**Re: Mulhern residential subdivision – drainage report revisions  
Tax Map 10, Lot 8-6  
91 Bagdad Rd, Durham NH 03824**

Attached is brief summary of the modifications made to the proposed stormwater drainage for the Mulhern subdivision since the previously submitted drainage report dated 2021-04-21. The changes that have been made are considered minor and with little impact to the results of the HydroCAD model.

**POST-DEVELOPMENT  
 CONDITIONS PLAN**  
 prepared for  
 MULHERN  
 TAX MAP 10, LOT 8-6  
 93 BAGDAD ROAD, DURHAM, NH 03824

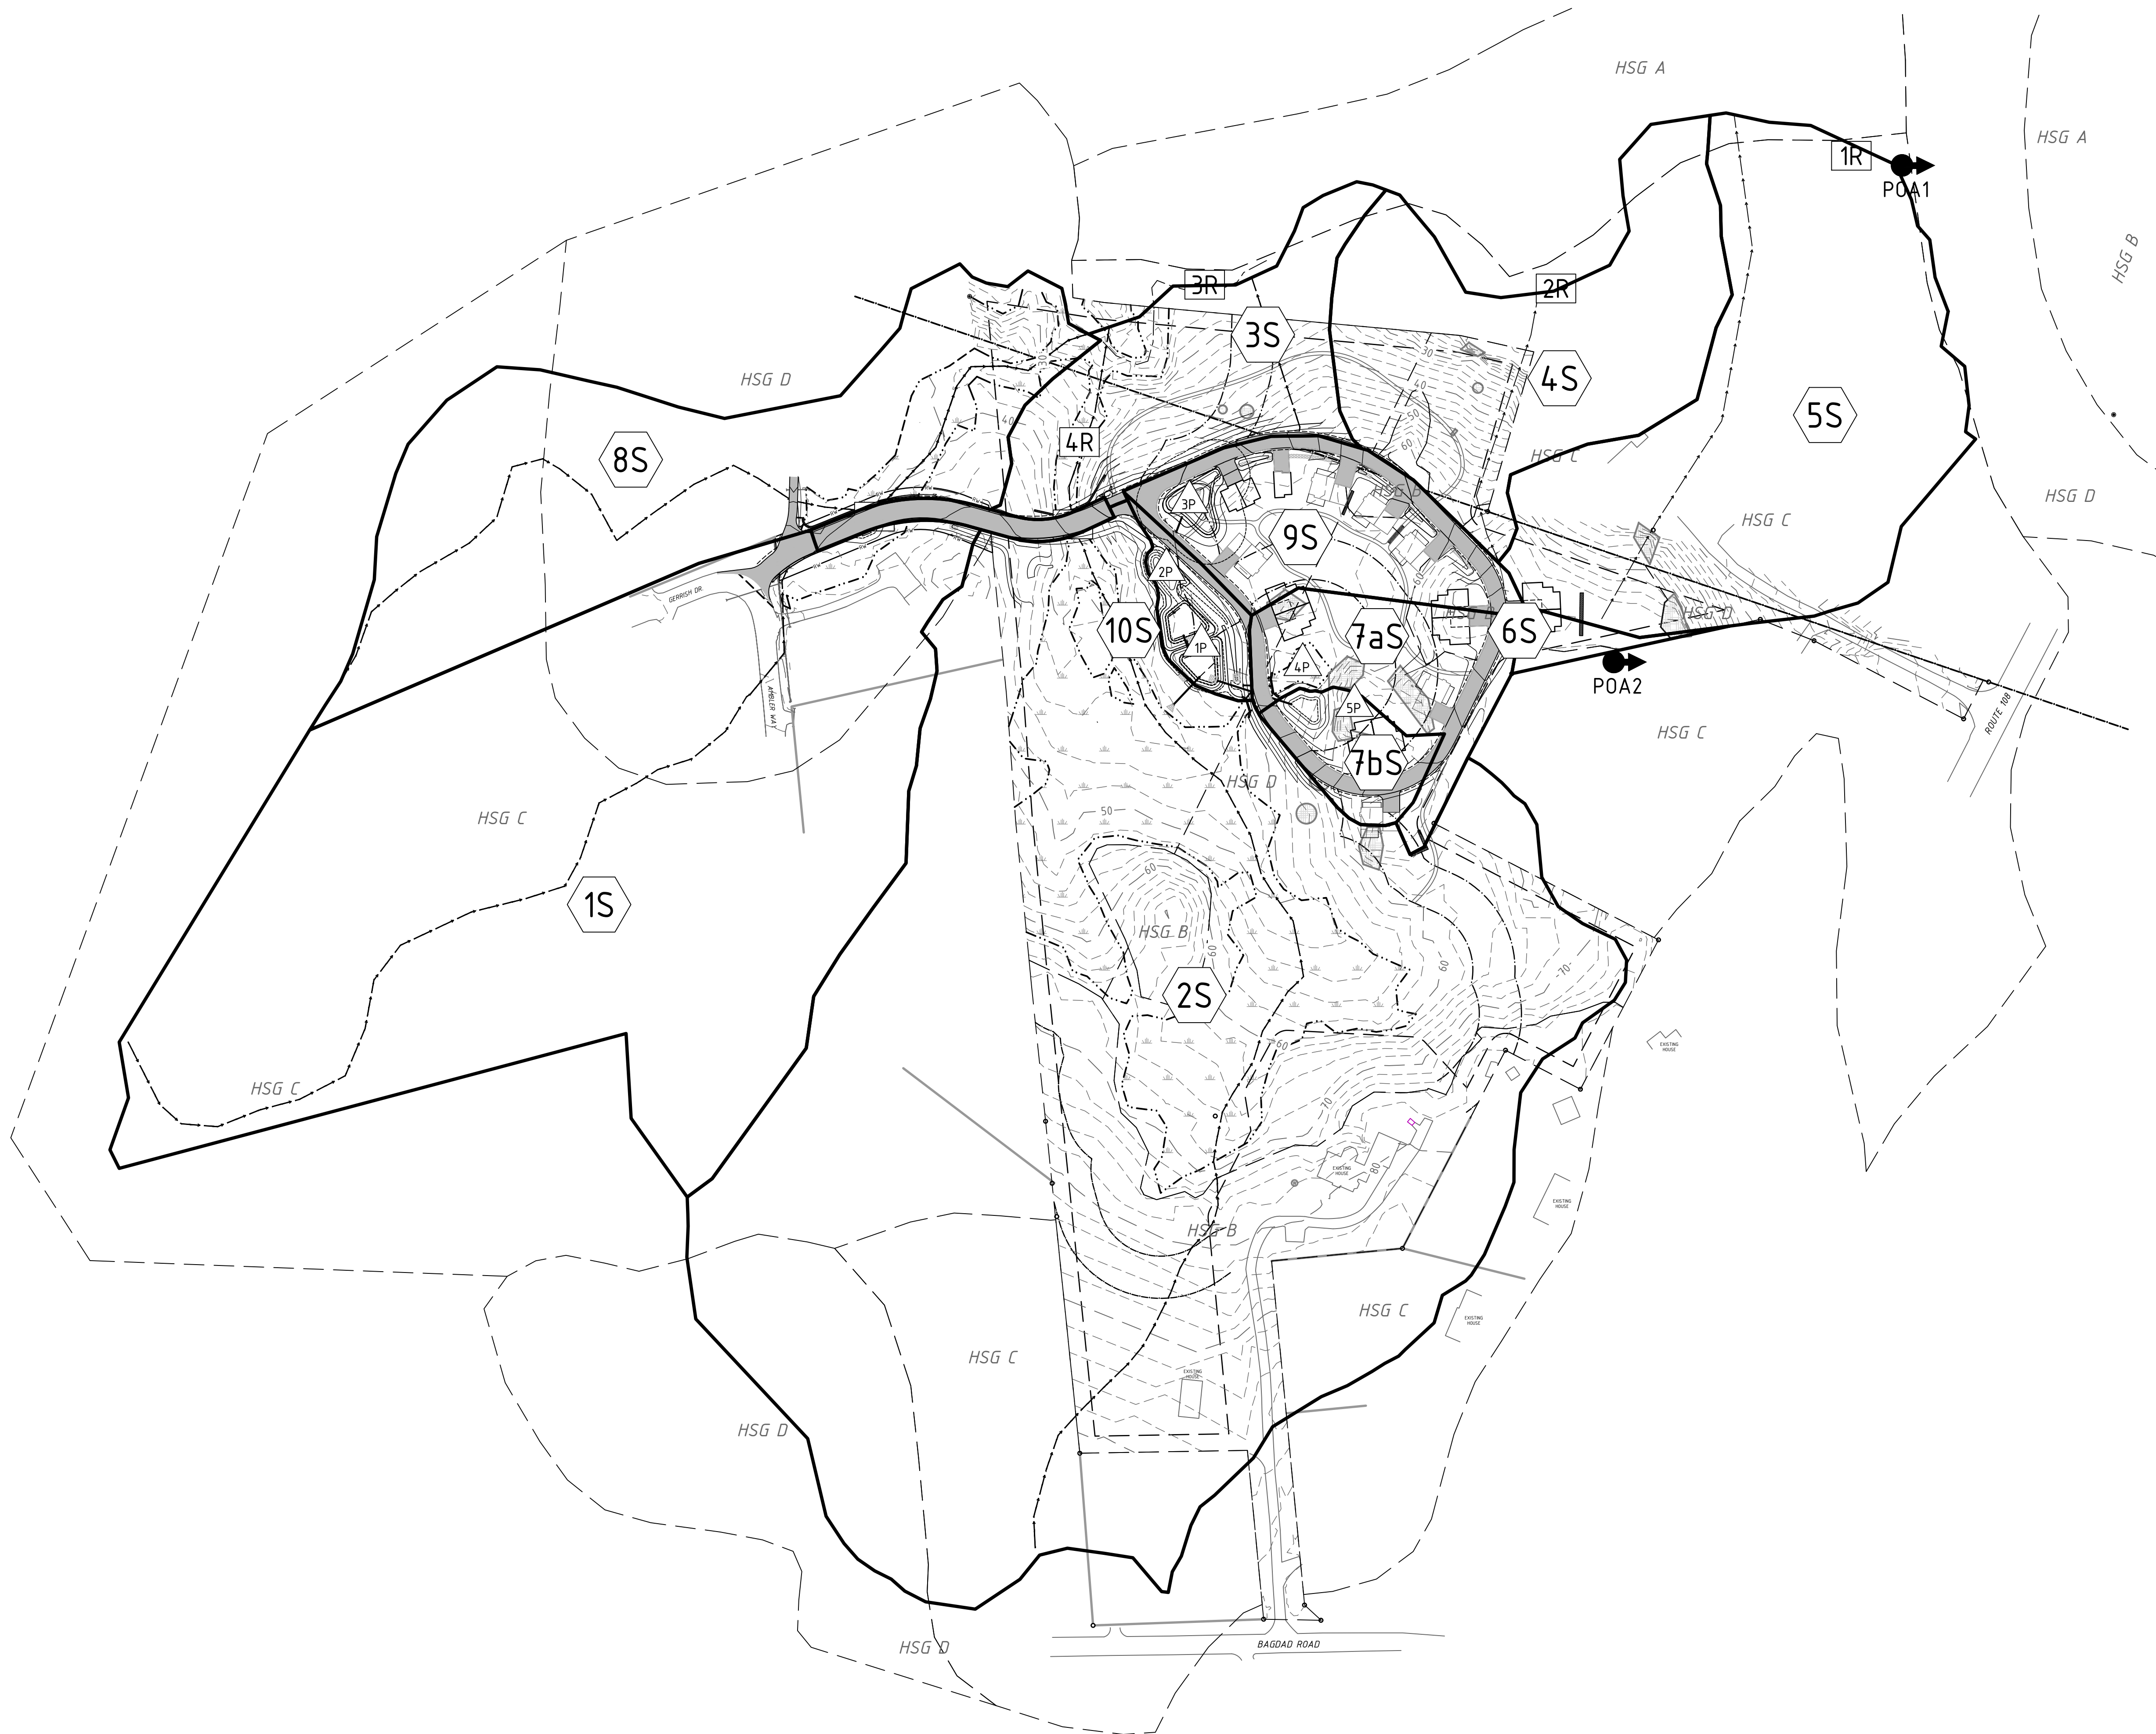
*1. Additional residential buildings have been proposed.*

The new site plan shows an increase to the impervious roof area by less than 6000 ft<sup>2</sup>. Please note that the building footprints shown are to establish feasibility and for illustration only. The exact footprint of the buildings may vary. A total of 6000 ft<sup>2</sup> of impervious area was added in the HydroCAD model to account for these modifications (3000 ft<sup>2</sup> to 7aS and 7bS).

*2. Modified inverts of proposed box culvert at the first wetlands crossing*

The slope of the box culvert was changed slightly. The change in slope has a negligible impact on the flow at the culvert and at the downstream point of analysis (POA 1).

NO.	REVISIONS	DATE	INT.
3.	REVISED BUILDING LAYOUT	10/04/21	MCS
2.	REVISED PER ENGINEERING REVIEW	4/20/21	MCS
1.	REVISED DRAINAGE DESIGN	2/11/21	MCS
0.	INITIAL SUBMISSION TO THE DURHAM PLANNING BOARD	12/9/20	MCS
